Hearing evidence for application RM22.434 by Cold Gold Clutha Limited.
Submitter: Anthony Ohau Ward-Holmes
Date: 9 November 2023

A family on a multi-day canoe trip from Lake Wānaka to Beaumont.

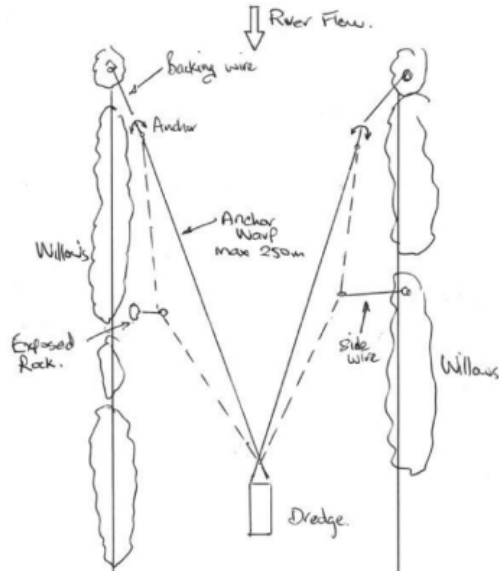
Note that people with a variety of skills and craft descend the Upper Clutha, not all of them experts. Some are students or beginners. Some are backpackers on inflatable unicorns. Some are people in unforgiving craft such as long and fast, but tippy and difficult to turn, multi-sport kayaks. Some are on multi-day trips with heavily loaded, and so slow, boats. Some are families with small children.
